INDIANA HARBOR BELT RAILROAD COMPANY

BULLETIN ORDER NO. S-37
Effective: 0600 Sunday April 7, 2024

April 5, 2024
General Orders in effect: 102

89. TIMETABLE SPECIAL INSTRUCTION 2900 - SIGNAL ASPECTS AND INDICATIONS – REVISED 7/16/2021:

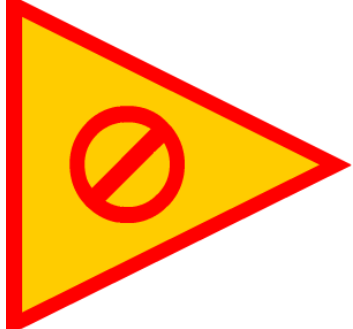
Effective 0600 7/16/2021, employees will be governed by image as shown below. Managers will use the Reflectorized Triangle to simulate an improperly lined switch or derail to monitor compliance with GCOR 6.27, GCOR 6.28, and GCOR 8.2. Managers will also use the Reflectorized Triangle to simulate a contaminated flange way to monitor compliance with GCOR 6.32.1 SI 2409. Employees must make a notation on page 113 of IHB Timetable No. 3 that the rule is changed in this notice. In the near future a sticker will be made available to make the modification to page 113. Foreign line crews make the same change to page IHB-42 in the CORA Guide.
